# Access Compliance Report

## Public Rights-of-Way

### (Curb Ramps)

Intersection ID: 43762	Main Street: HELENS_LN	Cross Street: ZIEGLER_LN	Location: NW
ADA ID: A75252B17438	Ramp Type: PerpDiag	Initial Pass/Fail: Fail	Overall Compliance: No
			Severity Score: 33.75

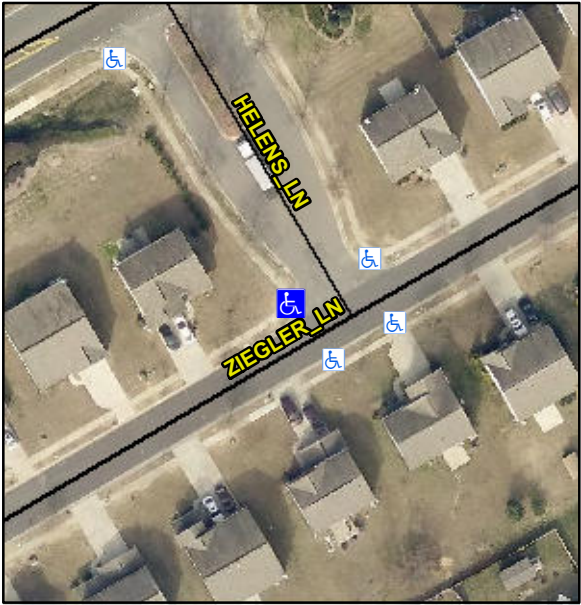
Codes/Mitigation Info/Possible Solution			Field Measurements/Component Compliance		
	Possible Solutions:		<b>Compliance</b>	<b>Description</b>	<b>Data</b>
	<b>Remove &amp; Replace Curb Ramp With Two New Directional Ramps or Equivalent.</b>		<b>No</b>	Ramp Length (in)	48.0
			<b>No</b>	Ramp Width (in)	38.0
			<b>N/A</b>	Flare Type LT	N/A
			<b>N/A</b>	Flare Slope LT (%)	N/A
			<b>N/A</b>	Flare Traversable LT?	N/A
			<b>N/A</b>	Landing Length (in)	N/A
			<b>N/A</b>	Landing Width (in)	N/A
			<b>N/A</b>	Landing Slope (%)	N/A
			<b>N/A</b>	Landing X Slope (%)	N/A
<p>Surveyor Notes:</p> <p><b>N/A</b></p> <p>PROW/ADA:</p> <p><b>R304.5.1, R304.2.2, R304.5.3</b></p>			<b>N/A</b>	Flare Type RT	N/A
			<b>N/A</b>	Flare Slope RT (%)	N/A
			<b>N/A</b>	Flare Traversable RT?	N/A
			<b>N/A</b>	DWS Provided?	N/A
			<b>N/A</b>	DWS Contrast?	N/A
			<b>N/A</b>	DWS Length (in)	N/A
			<b>N/A</b>	DWS Full Width?	N/A
			<b>N/A</b>	DWS Offset (in)	N/A

<b>N/A</b>	Gutter Ponding?	N/A
			<b>N/A</b>	Gutter Lip Ht (in)	N/A
			<b>No</b>	Painted X Walk1?	No
				X Walk 1 Direction	To S
			<b>N/A</b>	X Walk 1 Width (in)	N/A
			<b>0.0</b>	X Walk 1 Slope (%)	0.0
			<b>4.0</b>	X Walk 1 X Slope (%)	4.0
			<b>N/A</b>	Ramp inside XWalk1?	N/A
			<b>2.3</b>	Road Slope (%)	2.3
			<b>1.4</b>	Road X Slope (%)	1.4
			<b>N/A</b>	Any Obstructions?	N/A
				Obstruction Type	
Total Cost: \$ 3200.00			<b>N/A</b>	Storm Grate/Utility Hazard?	N/A
			<b>N/A</b>	Storm Grate/Utility Type	N/A
			<b>Yes</b>	Surface Condition? (G/P)	Good
